Accessibility Design

ASSESSMENT REPORT

Project: ESR Banksmeadow Estate

Report no: ADAR_24140_R1.1

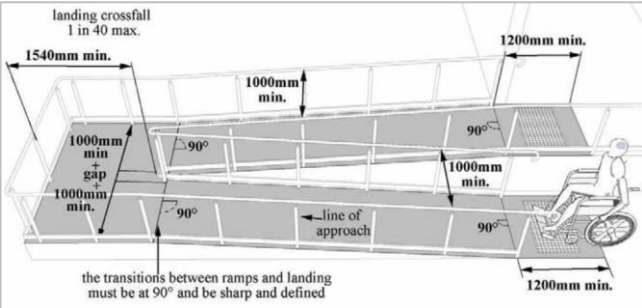
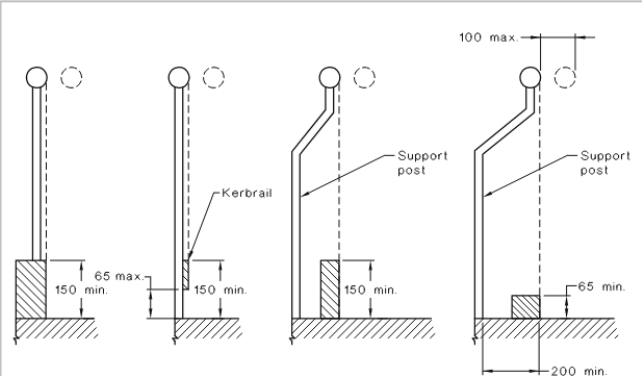
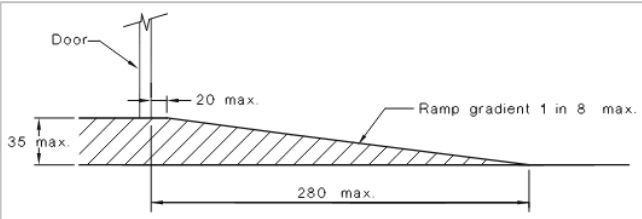
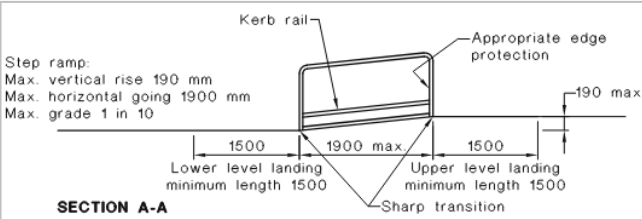
NCC / BCA Clause	DtS Provision	Compliance Commentary	Status
		  All floor surfaces to be slip resistant (Refer to clause D3D15 of the BCA and slip resistance guideline/handbook HB_198-2014).	
D4D3	Access to buildings (1) An accessway must be provided to a building required to be accessible —	Access is provided to the building from the main pedestrian entry at the allotment boundary (Wentworth Avenue and Moore Street) and from the accessible carparking spaces on the allotment in accordance with clause D4D3 as depicted in the markup below:	CRA

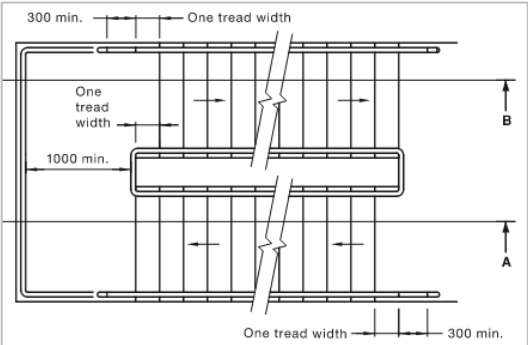
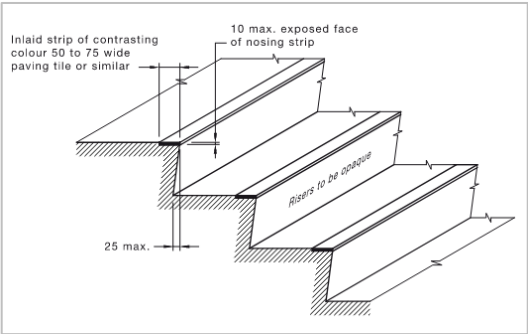
NCC / BCA Clause	DtS Provision	Compliance Commentary	Status
	(a) an accessible pedestrian entrance with multiple doorways is considered to be one pedestrian entrance where— (i) all doorways serve the same part or parts of the building; and (ii) the distance between each doorway is not more than the width of the widest doorway at that pedestrian entrance; and (b) a doorway is considered to be the clear, unobstructed opening created by the opening of one or more door leaves. (5) Where a doorway on an accessway has multiple leaves, (except an automatic opening door) one of those leaves must have a clear opening width of not less than 850 mm in accordance with AS 1428.1.	 Moore Street Key design matters to be addressed at the DD Stage – • Pedestrian links and accessways to comply with AS1428.1-2009. • Detail transitions at the allotment boundary to ensure gradients and crossfalls do not exceed 1:40.
